SERVICE BULLETIN

SB No. 56 Issue No. 2

TITLE
INSPECTION OF AIR INTAKE BOX BY-PASS FLAP HINGE.
CLASSIFICATION

Pre Mod M595 T67M and T67M-MkII.
 T67M200.

FIG. 1.

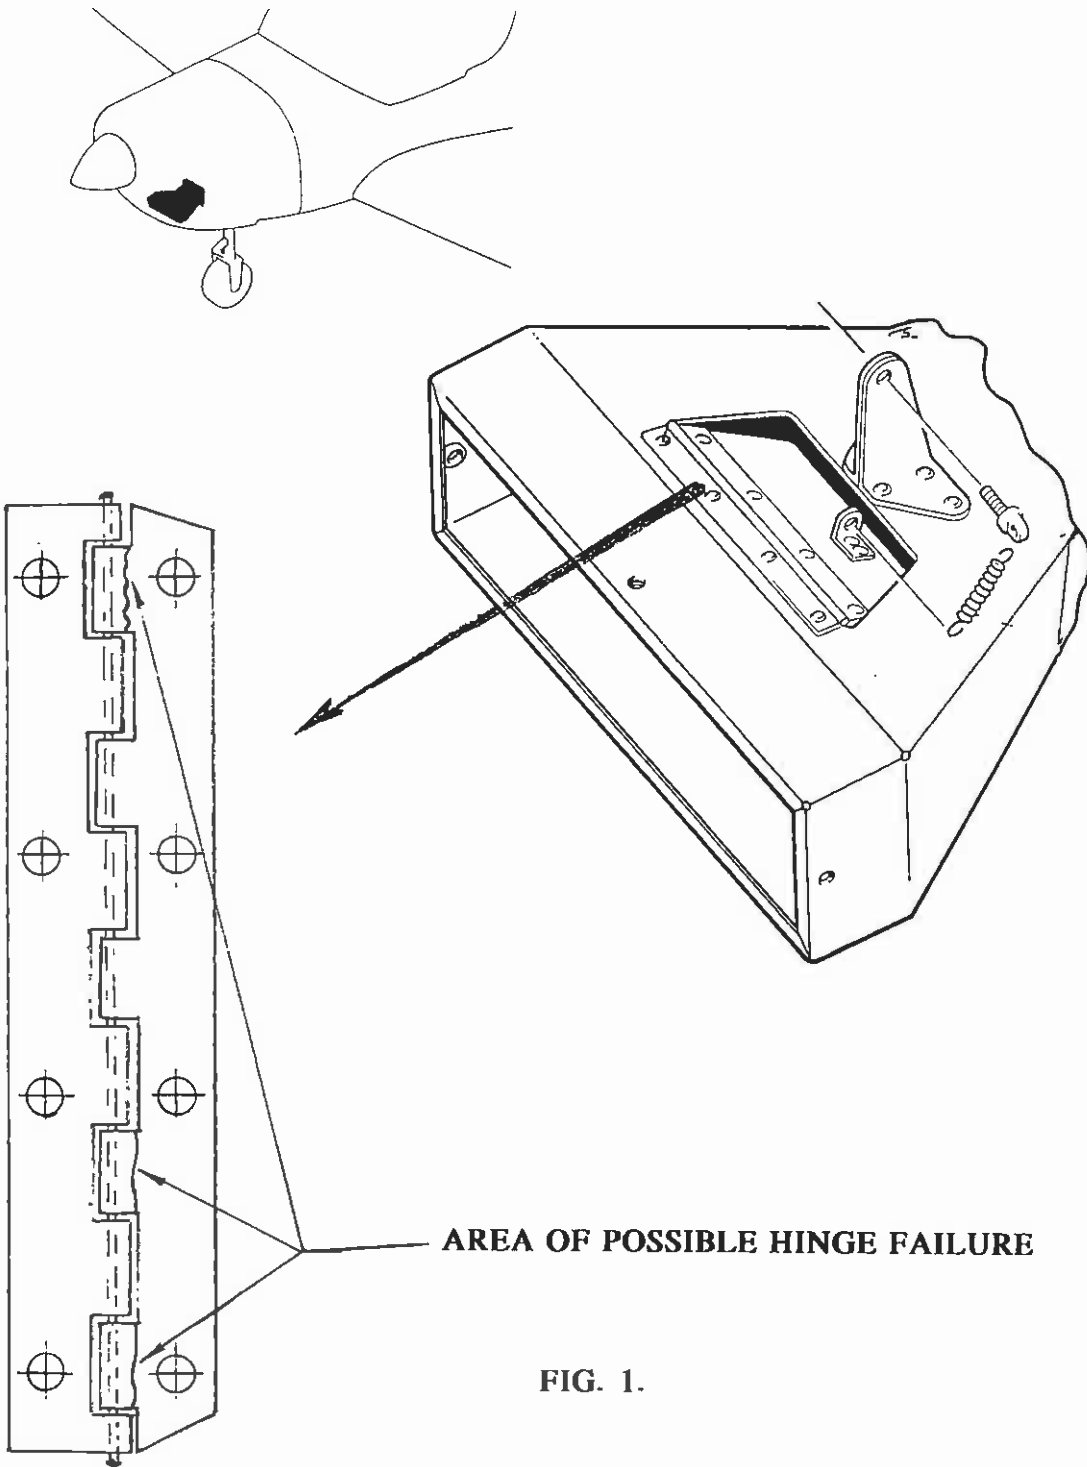
1. Inspect the Air Duct Assembly for signs of loose rivets and loose hinge pin. Particular attention should also be paid to each piano hinge segment as cracks can develop in the area shown in Fig 1.

2. If three or more hinge segments are found to have cracked or loose hinge pins are found, the unit is not acceptable for continued service. Fit aircraft with new* or repaired unit and inspect i.a.w. Para 4.

3. If one or two hinge segments are found to have cracked the aircraft can continue to fly subject to further inspections at subsequent 50 hour checks, until paragraph 2 applies.

4. If no damage or cracks found, continue as applicable below:
 - 4.1 Ref T67M and T67M-MkII: If no cracks or damage are found repeat this inspection at every 50 hour check until para 2 or 3 applies.*

- 4.2 Ref T67M200: If no cracks or damage are found, repeat this inspection at every subsequent 150 hr check until para 2 or 3 applies.
